PCN No.:	AAA1501181	Date:	23.07.2018
Product:	(G)MSTB(P)(T) 2,5/ST(F)AU

Description of change Product appearance (fit) Product geometry (form) Product function (function) Conversion to partially gold-plated surface

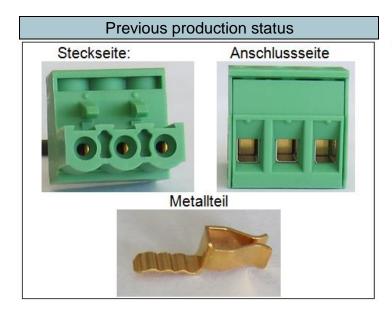
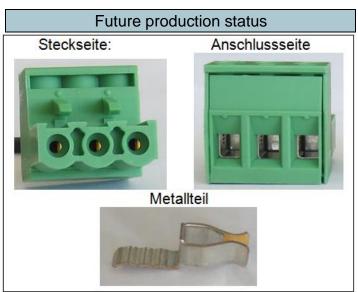
In order to optimize the production process, the surface of the metal part has been changed from fully goldplated to partially gold-plated. This change does **not** result in the contact resistances increasing. This change does not affect the dimensions or technical data, either. Depending on the amount of stock and the number of positions, both versions will be supplied in parallel during the changeover phase.
